Ref 11.260I02

19 July 2012

Proposed Educational Establishment at 2964 Wisemans Ferry Road, Mangrove Mountain Re:

DA 42013/2012

Attachments: 1) Ground Floor Plan with Superimposed Swept Paths

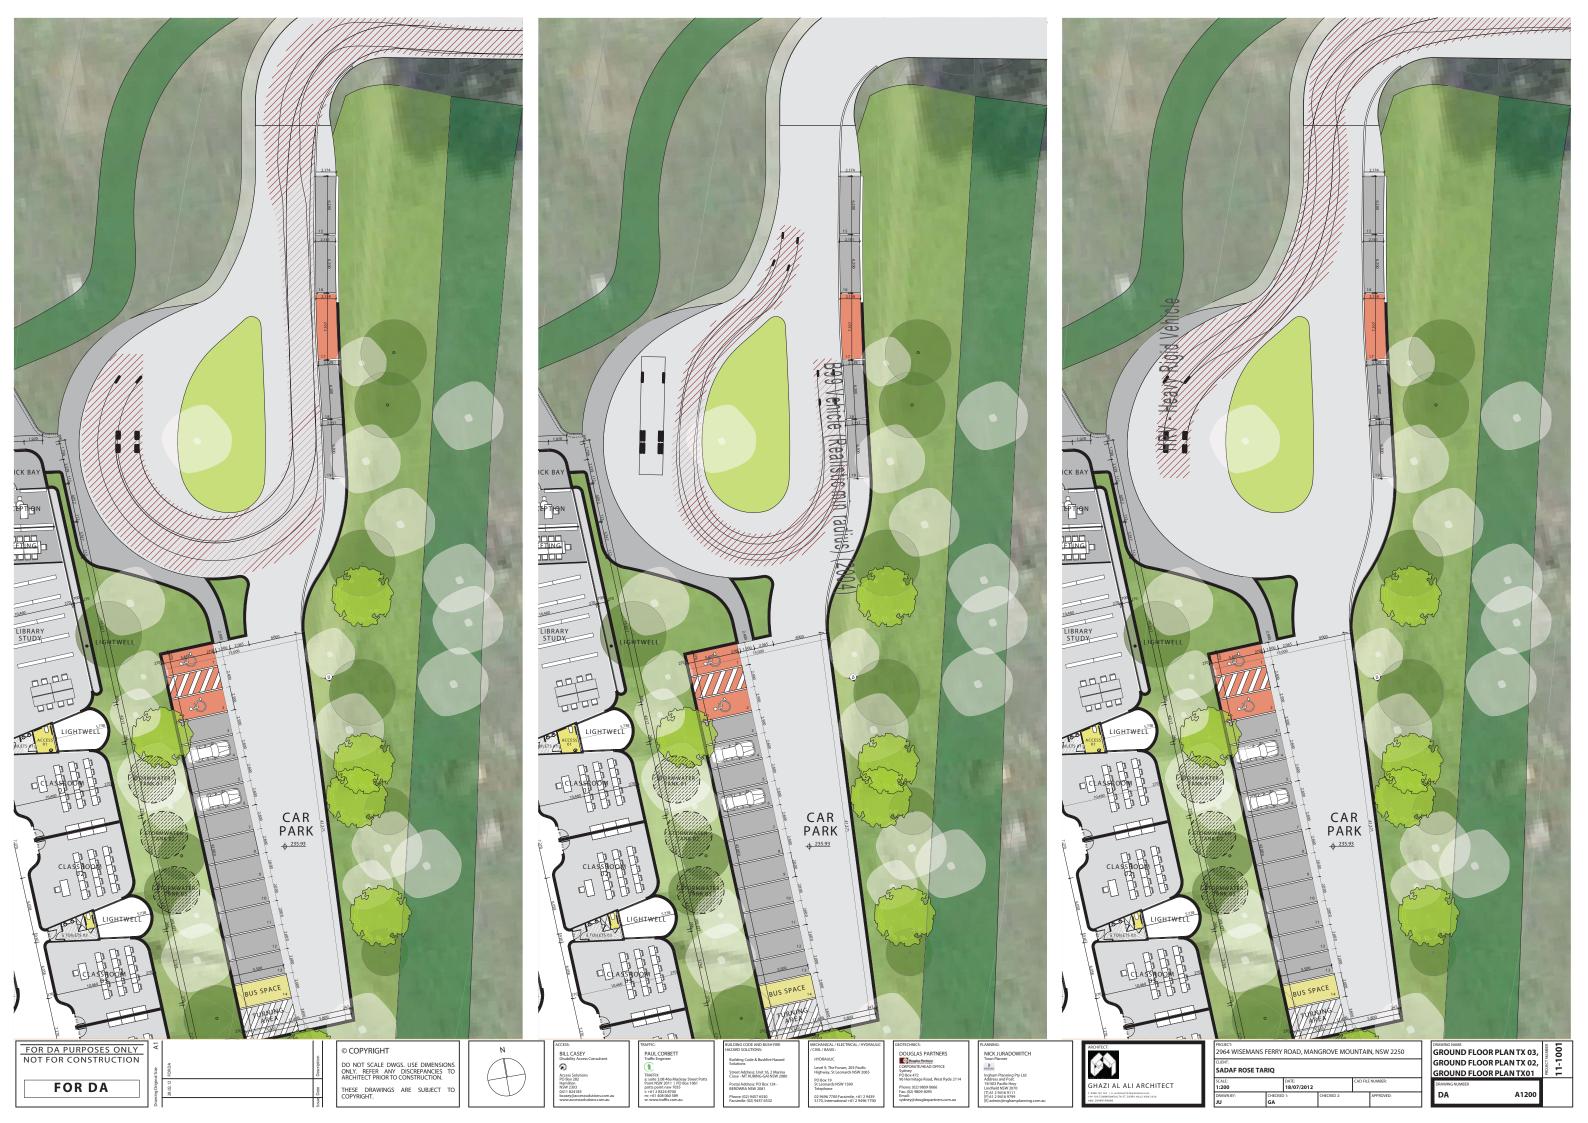
The Applicant shall submit revised plans detailing the proposed turning area, parallel parking area and access driveway to ensure compliance with AS/NZS 2890.1 (2004) - "Off-street car parking". Additional manoeuvring templates for the required Heavy Rigid Vehicle shall also be provided through this turning area.

The plans have been amended to incorporate dimensions and superimposed swept paths, which demonstrates compliance with AS 2890.1 (2004) and AS2890.2, as appropriate. The revised plans are included in Attachment 1.

2) BAR and BAL Concept Plan

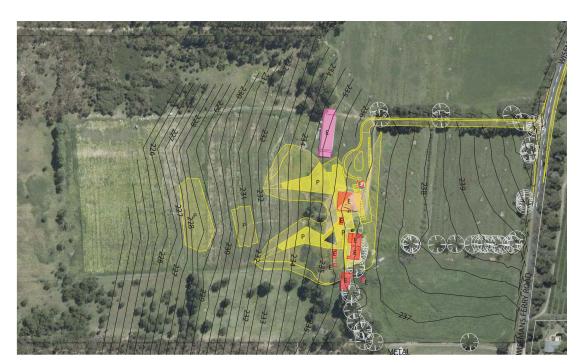
The Applicant shall submit revised plans which incorporate all the RMS recommendations in their correspondence dated 23/5/2012. In particular, the Basic Right Turn Treatment (BAR - refer Austroads Guide to Road Design Pt 4) in Wisemans Ferry Road.

In addition to the above, Council will require a formalised Basic Left Turn Treatment (BAL) and acceleration lane (northbound vehicles) along the western side of Wisemans Ferry Road. The Applicant shall also demonstrate that these required traffic safety measures will also result in 'zero impact' on the water quality in the Mangrove Weir Catchment (particularly during the construction phase).

The developer will provide a rural BAR treatment at the Wisemans Ferry Road access in accordance with RMS recommendations. The development will also provide a rural BAL treatment

at the Wisemans Ferry Road access, as requested by Council. Both these treatments will be designed in accordance the requirements of Austroads Guide to Road - Design Part 4. A Concept Plan of these treatments has been superimposed on the Site Plan, which is included in **Attachment 2**. The detailed design of the BAR and BAL will be provided at a later stage.
